STAFF MEMORANDUM

Subject: Frederick and Celia Lorden Trust (owner) and Gio Realty LLC (applicant) - Conceptual

discussion for a 48 unit residential development. The parcels are located at an unnumbered lot and 19 Ponemah Hill Road in the Residence B and Limited Commercial District. Tax Map 43, Lot

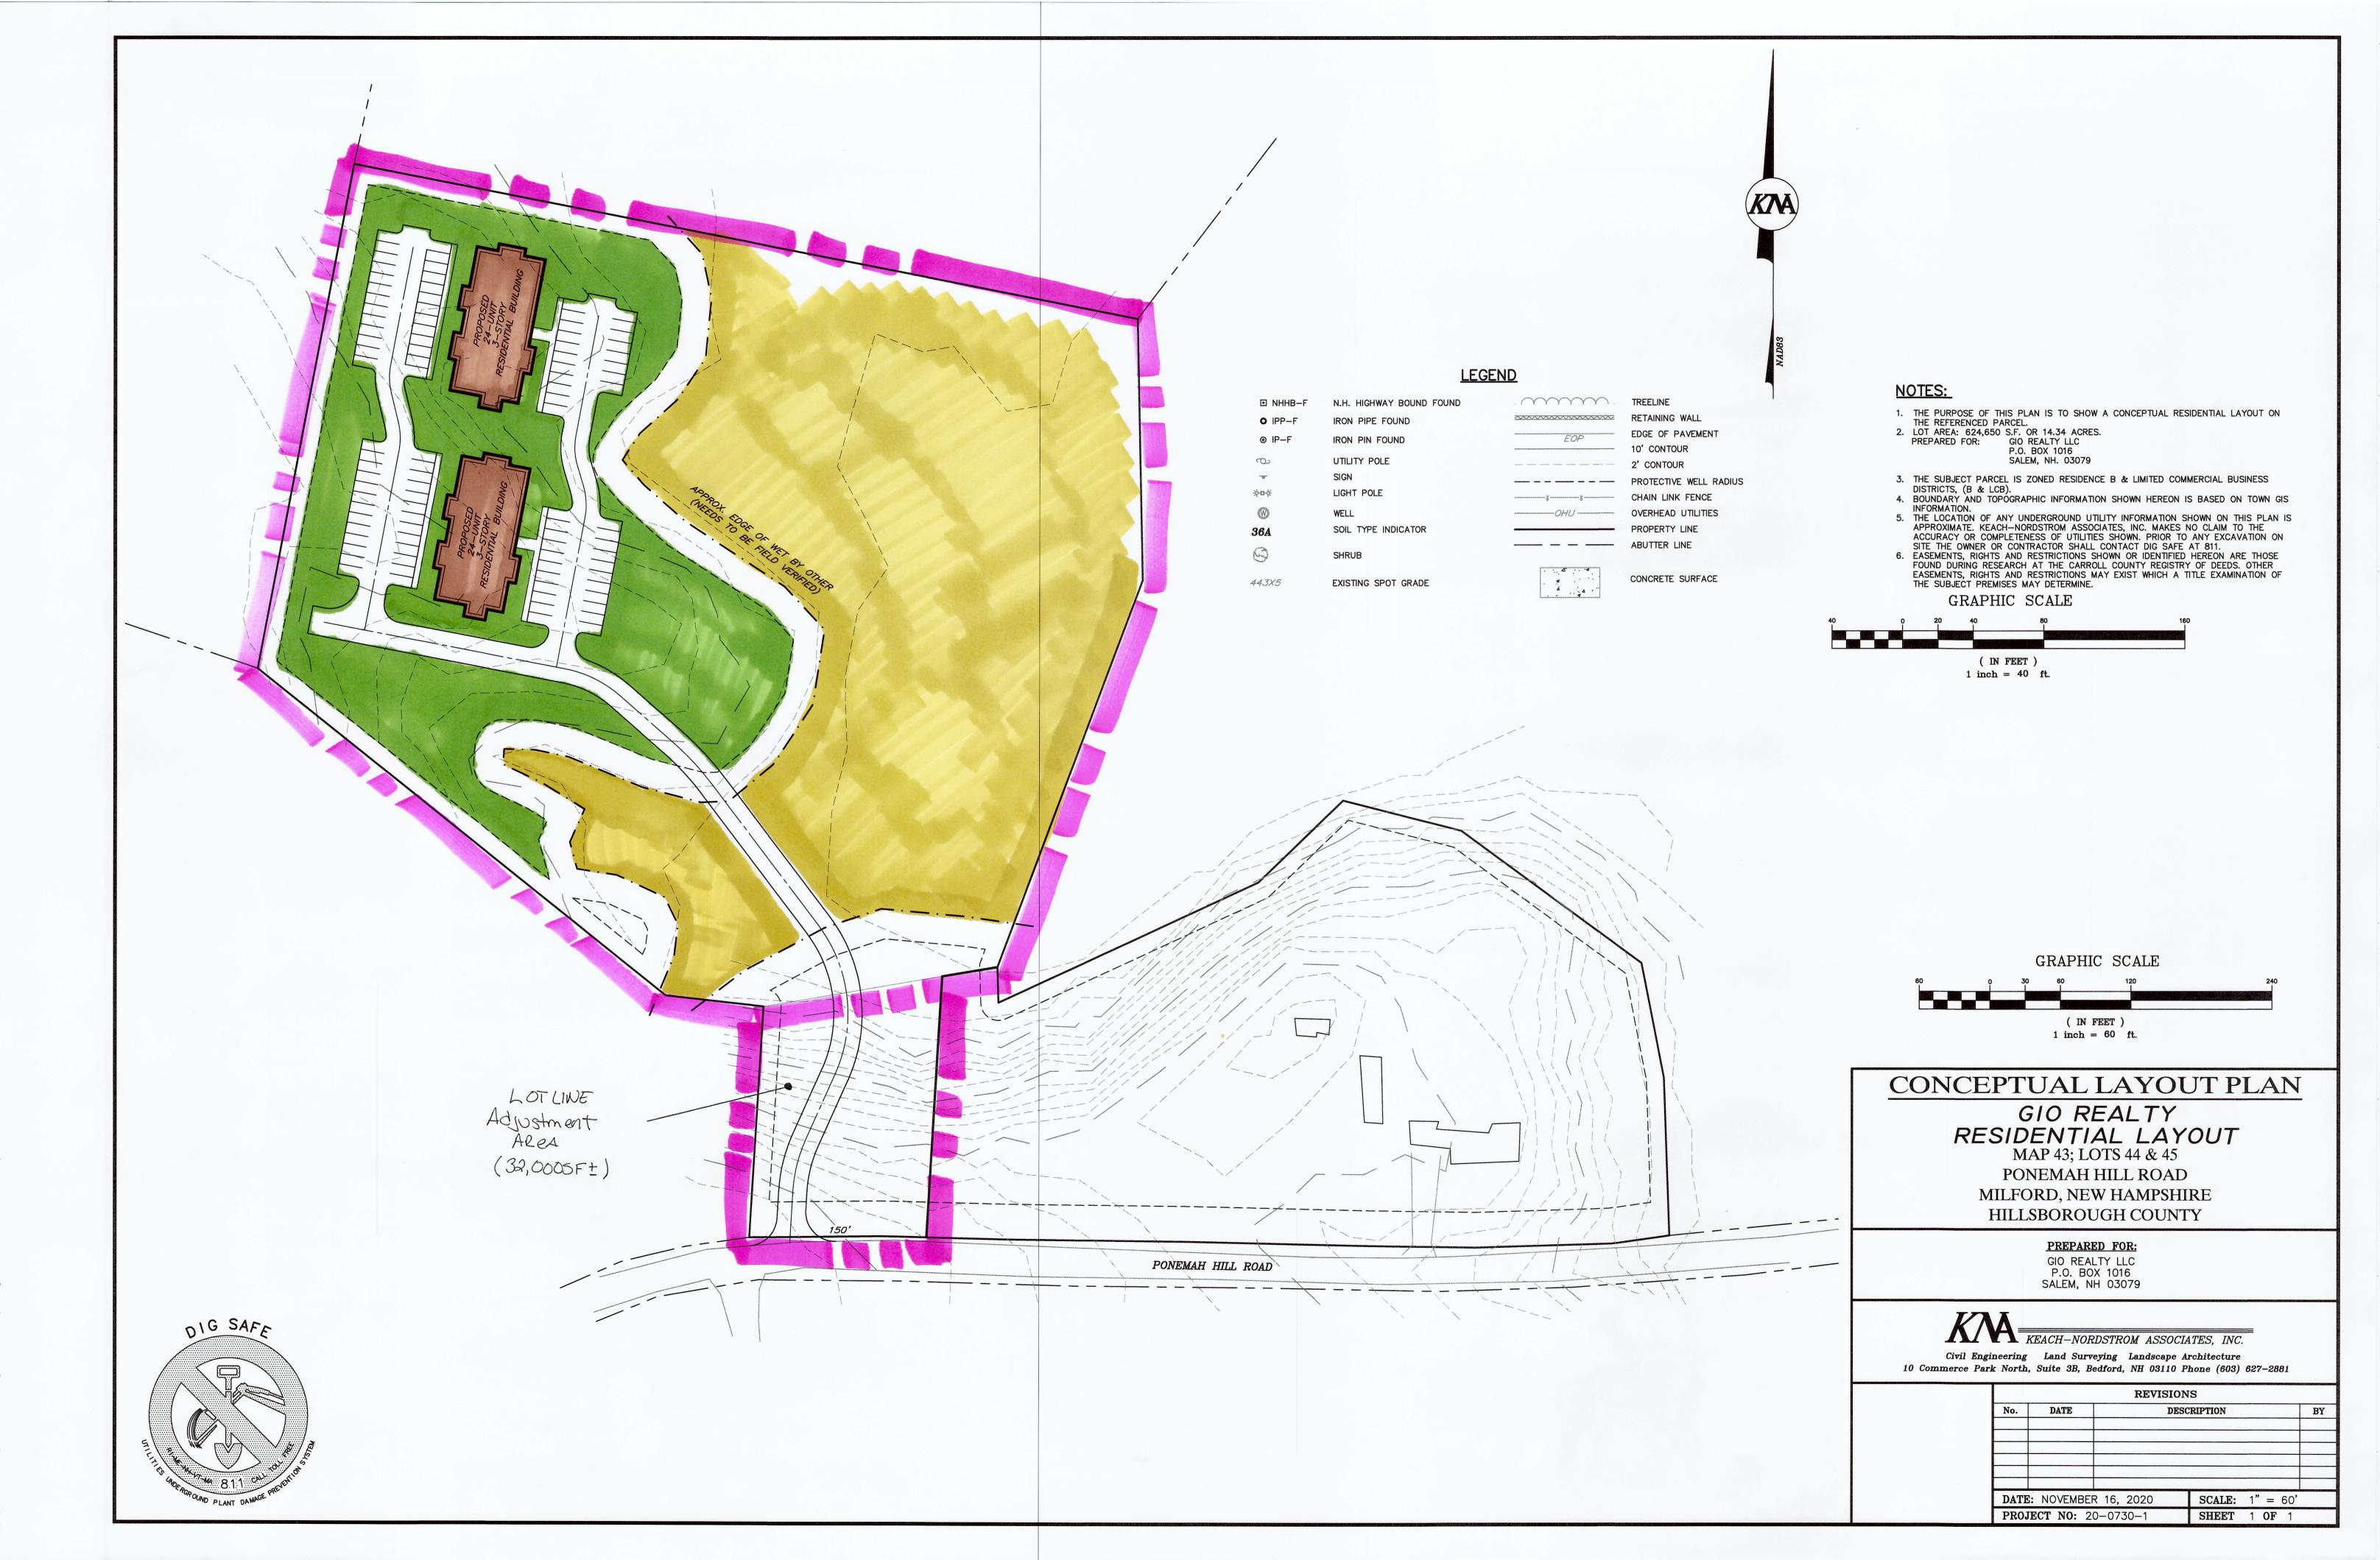
- 1. The maximum density calculation for Residence B zone for multifamily dwellings served by municipal water and sewer is five units per acre. The maximum density may be reduced by the Planning Board based on recommendations of other qualified consultants.

- 2. Staff would recommend a traffic study be conducted for the Ponemah Hill Road and Nashua Street intersection prior to any approval of development. This intersection is currently rated "F" per DOT standard and therefore any increase in volume to this intersection should be accounted for and improvements should be considered.

- 3. The minimum frontage requirement is 150 feet. The applicant has shown they can comply with this by way of a lot line adjustment.
- 4. The maximum height requirement for Residence B District is 35 feet. The applicant should confirm the 3 story buildings are compliant with this.

- 5. In addition to a lot line adjustment approval, the applicant will need to receive subdivision approval due to having more than 5 units (Milford Development Regulations, Section 5.08 Open Space Conservation Developments) and per Milford Development Regulations, Article III Section 3.01Definitions: Condominium.
